Westpointe West Offsite Sewer Extension – Phase I

Solicitation Number: CO-00255

ADDENDUM 2

January 23, 2019

PLAT NO.	N/A
JOB NO.	11581-02
DATE	JAN 2019
DESIGNER	RG
CHECKED	RG DRAWN EP
SHEET	C3.05

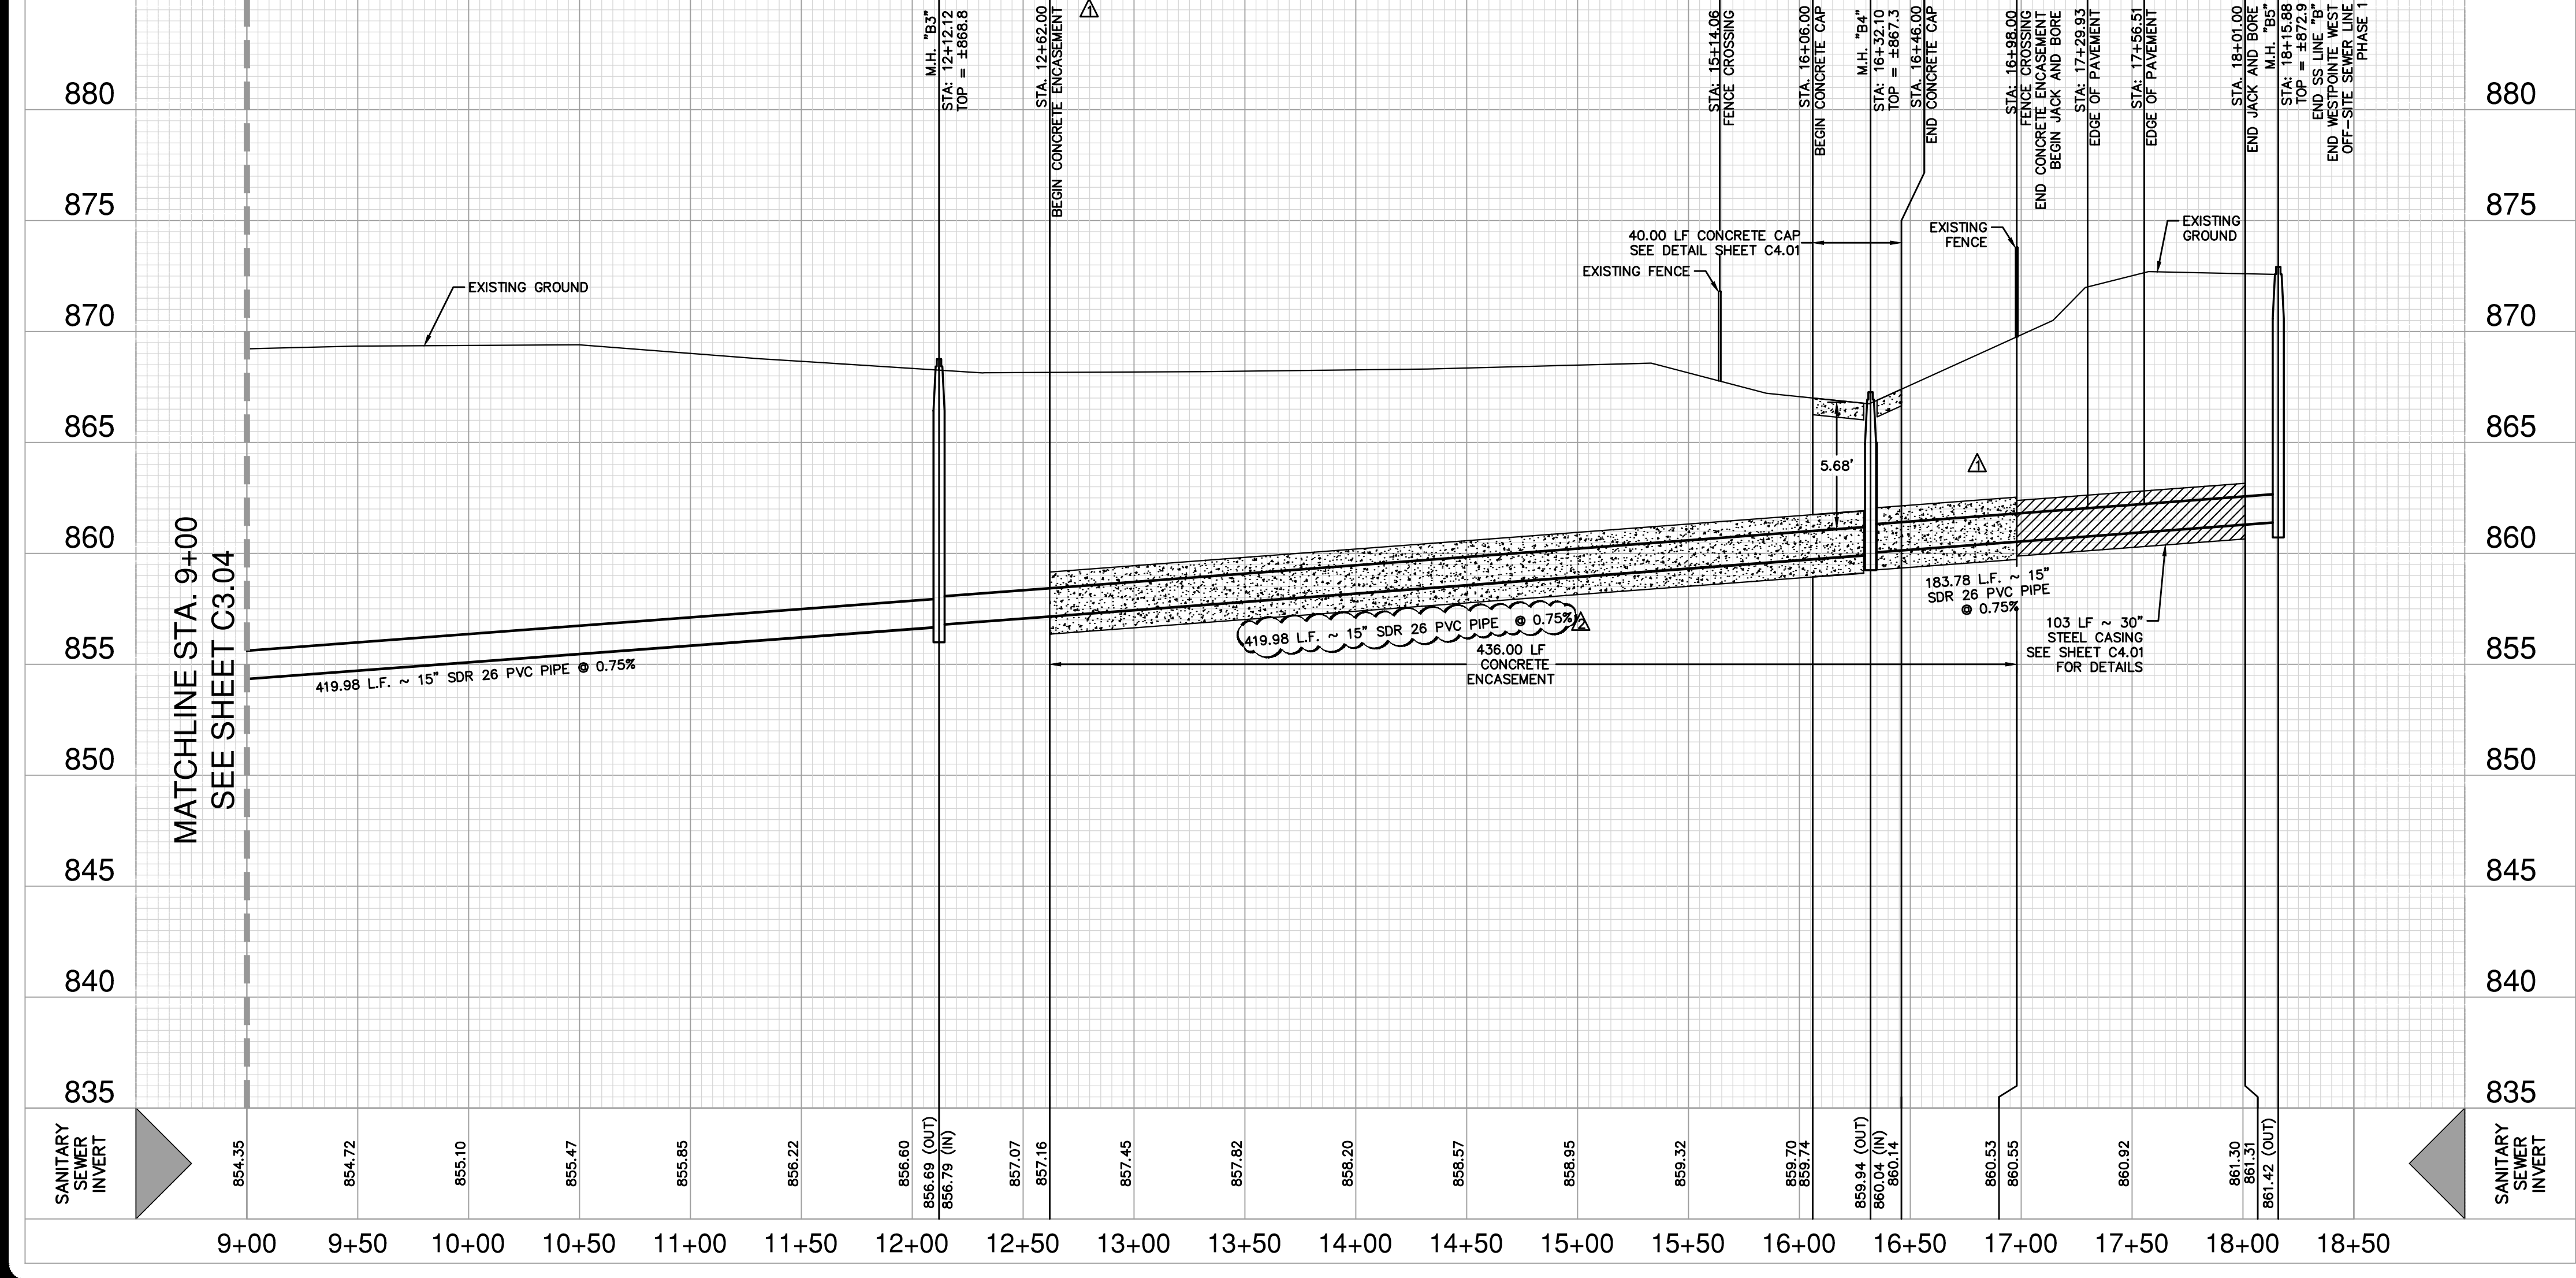
38. **Question: Between STA: 12 + 12.12 and STA: 16 + 46.00 there is a 15" FRP pipe. Should it be 15" PVC? There isn't a 15" FRP on the bid form**
Response: The callout for the pipe between Stations 12+12.12 and 16+32.00 has been revised on Sheet C3.05 to 15" SDR 26 PVC pipe.

Response: According to the surveyor, the structure seen on the Google Earth aerial image is a horse trailer that can be moved by the owner.
41. **Question: Need clarification on sheet C3.05 STA 12+00 on the 15" Sewer Line. The profile is showing 15" FRP SN72, is this supposed to be 15" SDR 26 Heavy Sewer Pipe or FRP SN72**

1. Sheet C3.05 Revise callout.
2. Added C5.00, C5.01, C5.02, C5.03

Response: The callout for the pipe between Stations 12+12.12 and 16+32.00 has been revised on Sheet C3.05 to 15" SDR 26 PVC pipe.
